# Access Compliance Report

## Public Rights-of-Way

### (Curb Ramps)

Intersection ID: 46489	Main Street: BALLYBAY_DR	Cross Street: TRAILMOOR_RD	Location: NE
ADA ID: 1AF994B3972C	Ramp Type: PerpDiag	Initial Pass/Fail: Fail	Overall Compliance: No
Severity Score: 10			
Codes/Mitigation Info/Possible Solution		Field Measurements/Component Compliance

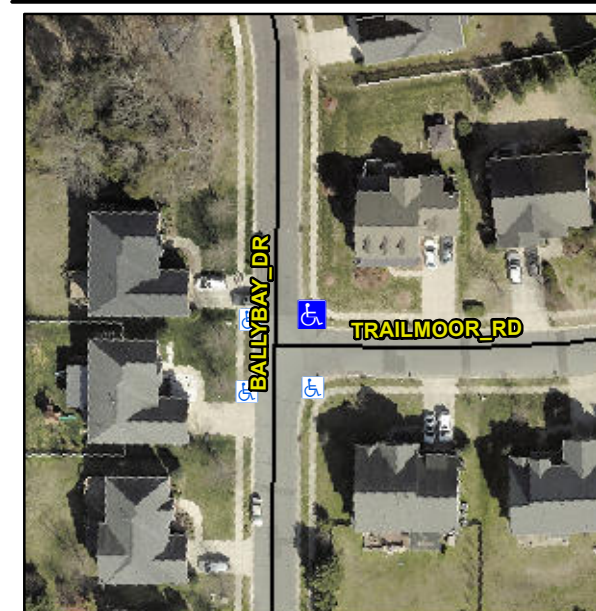
**Remove & Replace Curb Ramp With Two New Directional Ramps or Equivalent.**

**Not Found, R304.5.1, R304.5.3**
